UNITED STATES PATENT AND TRADEMARK OFFICE

10/019,195

| Office Action Summary | Application No. 10/019,195 | Applicant(s) HANNIG ET AL. | |

DETAILED ACTION

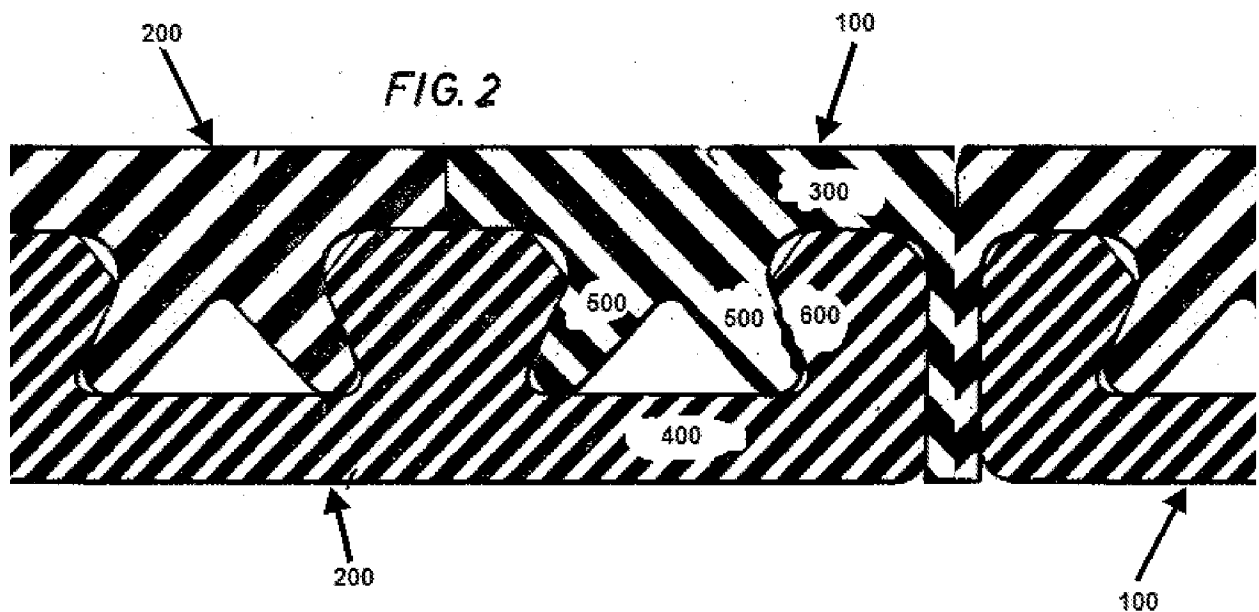
Claims 39-45 (as best understood by the examiner, see 35 U.S.C. 112 rejections above) are rejected under 35 U.S.C. 102(b) as being anticipated by Hoffmann USPN 3731445 (see marked-up figure below).

The prior art discloses applicant's claimed fastening system structure (as best understood by the examiner, see 35 U.S.C. 112 rejections above) to include a first panel (100) having a first hook projection (500), first leg (300) and inclined retaining surface (surface of 500 contacting 600); a second panel (200) having a second hook projection (600), second leg (400) and inclined retaining surface (surface of 600 contacting 500); there being a gap-free floor surface (where top

surface of 100 meets top surface of 200), there being a space (space extending between 600 and 300; and also extending between 600 and 500), in as much as applicant's own elected species does (see 35 U.S.C. 112 rejections above).
